Public Consultation
Submission Report –
First Non-Statutory
Public Consultation

BusConnects Dublin Core Bus Corridor Projects

Corridor 11 – Kimmage to City Centre

Emerging Preferred Route – Public Consultation Report 2018/2019

Section 1: KCR to Lower Kimmage Road / Sundrive Road [Kimmage Village].

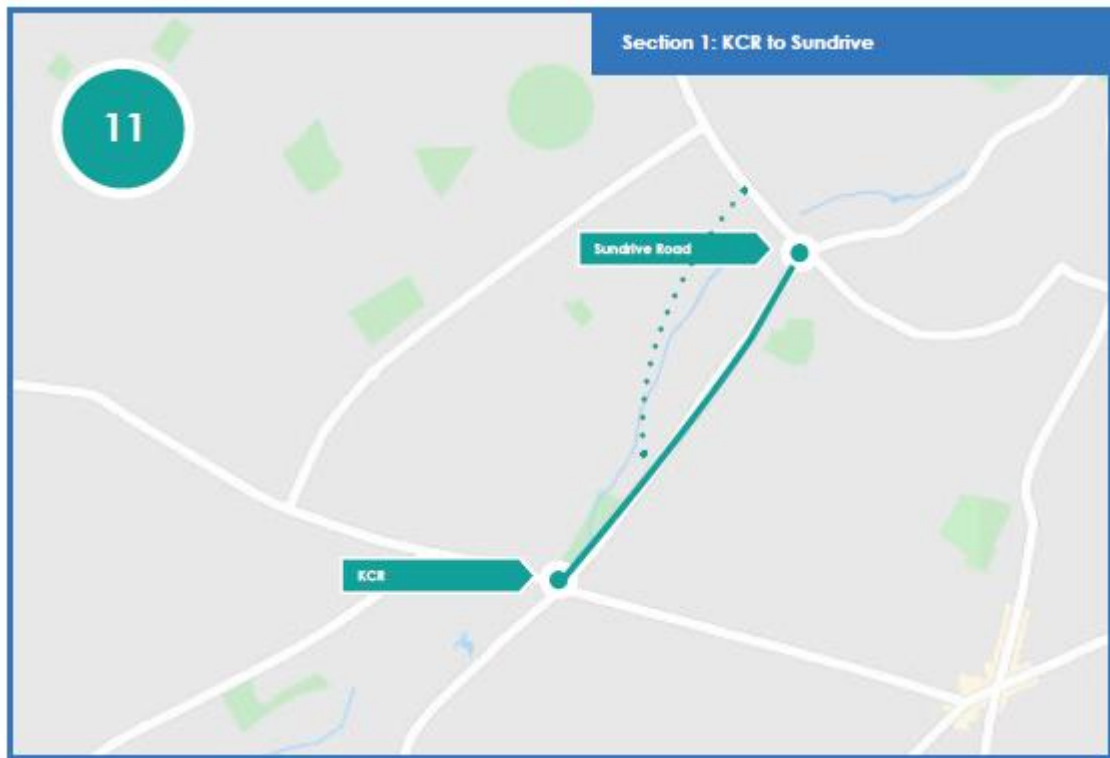
- Concerns over an increase in traffic along residential roads due to proposed bus gates; Concerns about fast cyclists on quiet roads;
- Concerns about the indirectness of the cycling route proposed;
- Concerns over reduced accessibility by car to their homes due to proposed traffic restrictions;
- Concerns over proposed widening of Lower Kimmage Road south of Sundrive Cross over a length of 0.5km, with land acquisition from approximately 40 properties to enable provision of bus lanes in both directions;
- Concerns about impacts on property values;
- Objections to the loss of parking spaces;
- Safety concerns, including pedestrian safety concerns;
- Queries about bus services and the need for the scheme;
- Community severance impacts; and
- Environmental impacts.

Section 2: Lower Kimmage Road / Sundrive Road [Kimmage Village] to Harold's Cross Park

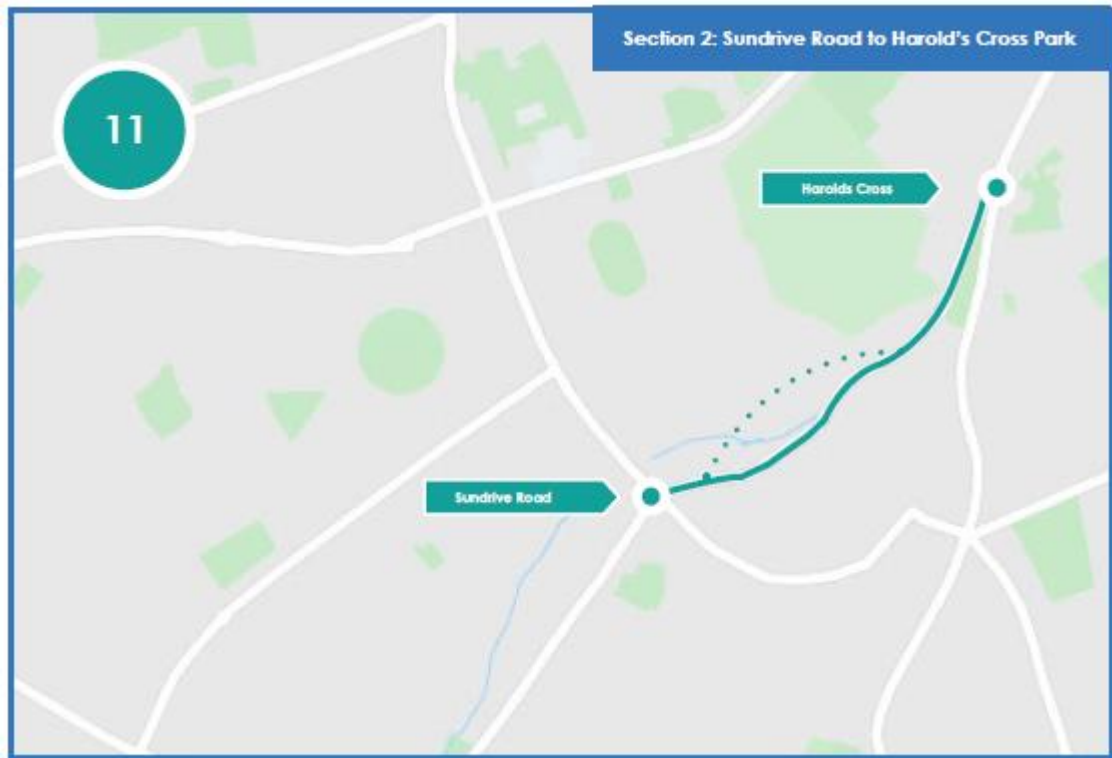
- Concerns over an increase in traffic along residential roads due to proposed bus gates; Concerns about fast cyclists on quiet roads;
- Concerns about the indirectness of the cycling route proposed;
- Concerns over reduced accessibility by car to their homes due to proposed traffic restrictions;
- Concerns about impacts on property values;
- Accessibility concerns to Mount Argus Church;
- Safety concerns at Harold's Cross National School due to traffic increases;
- General safety concerns, including pedestrian safety concerns;
- Queries about bus services and the need for the scheme;
- Flooding concerns at the River Poddle;
- Community severance impacts; and
- Environmental impacts.

Section 3: Harold's Cross Park to the Grand Canal

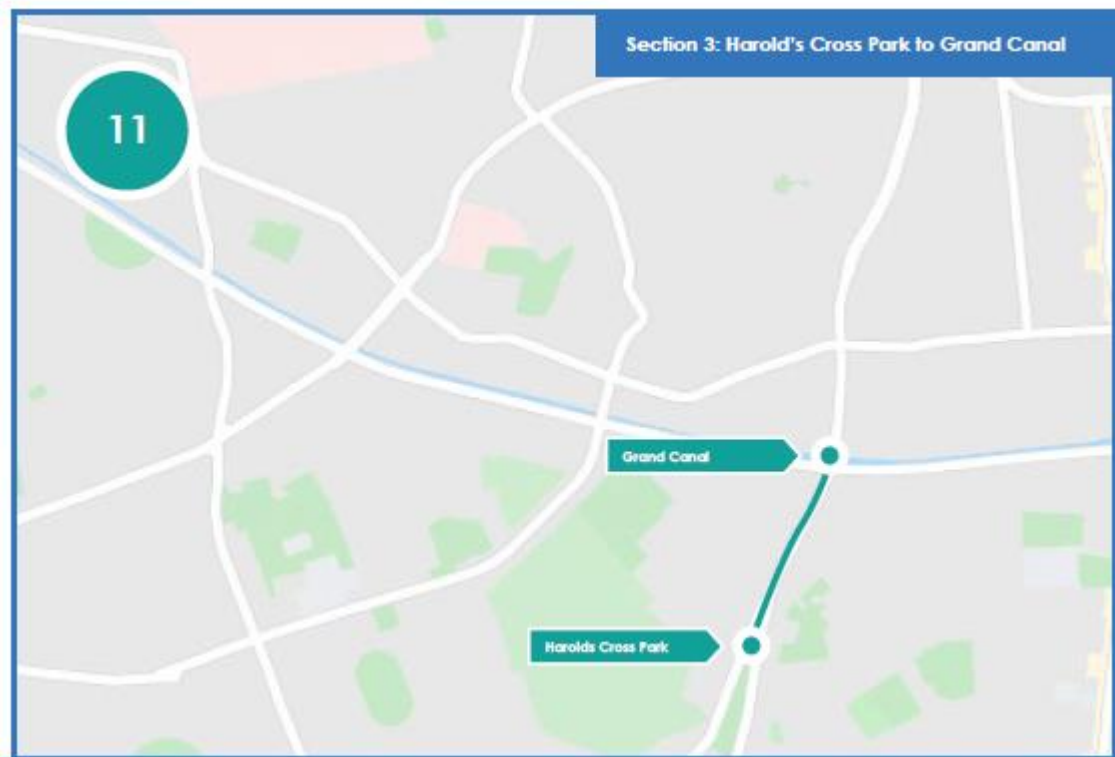
- Concerns over an increase in traffic along residential roads due to proposed bus gates; Concerns about fast cyclists on quiet roads;
- Objections to the proposed cycle route through the grounds of Our Lady's Hospice and along Greenmount Lane to Parnell Road at the Grand Canal.
- Objections to the loss of parking spaces;
- Concerns about impacts on property values;
- Concerns over reduced accessibility by car to their homes due to proposed traffic restrictions;
- General safety concerns, including pedestrian safety concerns;
- Queries about bus services and the need for the scheme;
- Flooding concerns at the River Poddle; and
- Environmental impacts.
